**Re: Revised DEIR for the Cabrillo Port LNG Deepwater Port
Docket No. USCG 2004-16877**

**Re: Comments of Southern California Gas Company to Revised Draft Environmental Impact Statement/Environmental Impact Report for Cabrillo Port Deepwater Port
Federal Docket No: USCG-2004-16877, State Clearinghouse No: 2004021107**

COMMENTS TO THE CABRILLO PORT LIQUEFIED NATURAL GAS DEEPWATER PORT PROJECT
REVISED DRAFT EIS/EIR
FEDERAL DOCKET # USCG 2004-16877
STATE CLEARINGHOUSE # 2004021107

Class I Impacts by Category

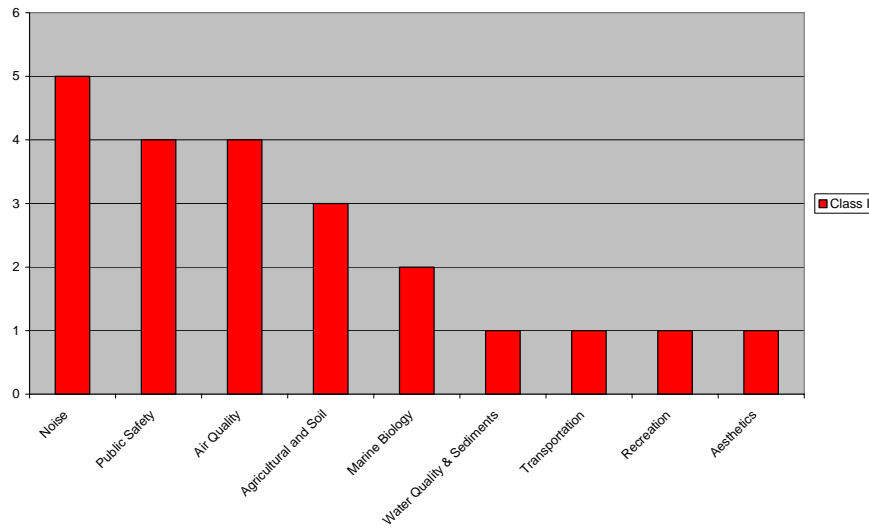
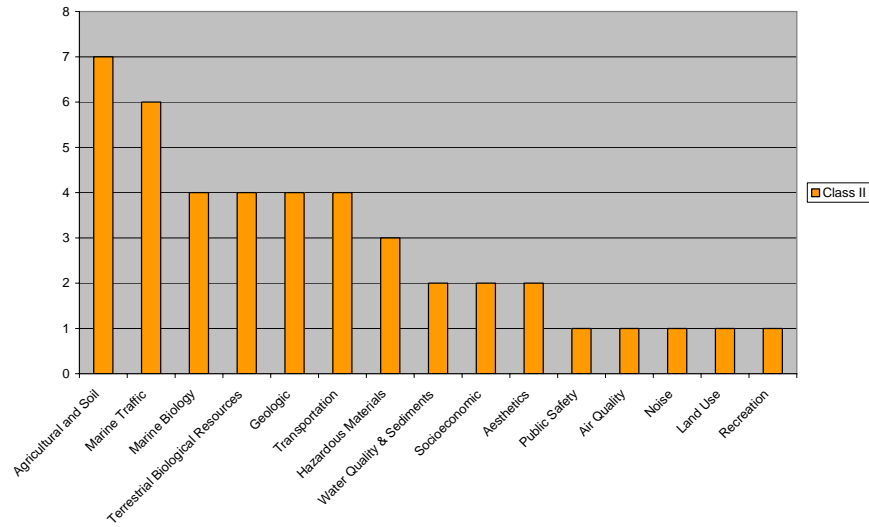
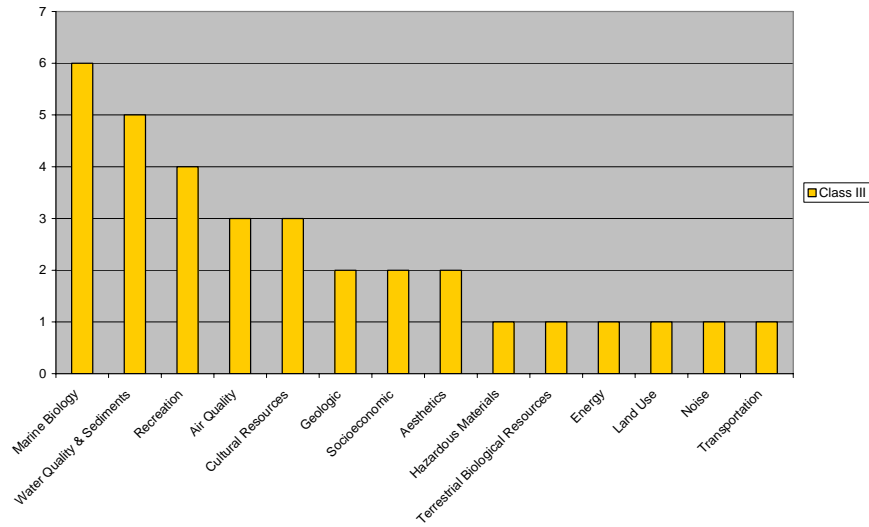
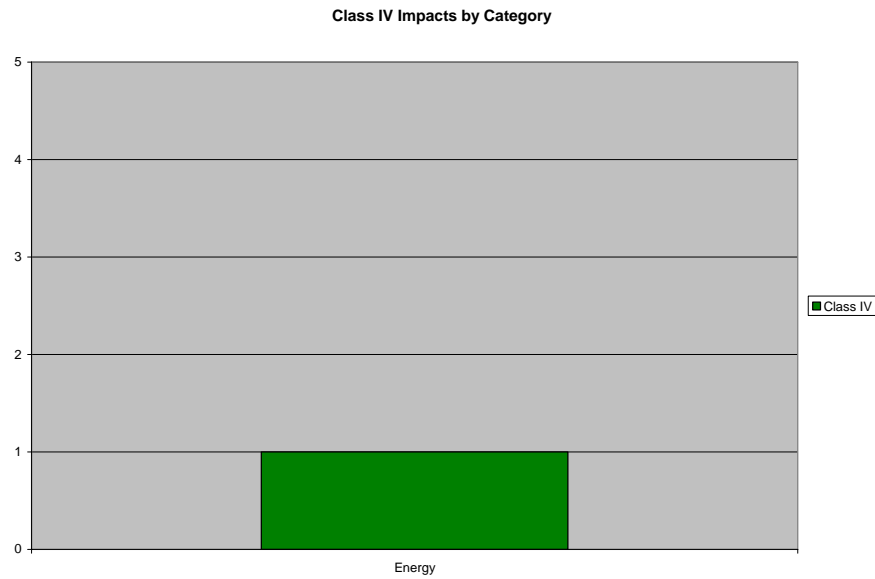
Below are my analyses from the impacts from the Draft EIR:

P018-6

As the reader can see, only ONE beneficial impact to California is energy. All other impacts are negative to California and more importantly, Ventura County. Do not let LNG into California!

P018-6
Thank you for the information.
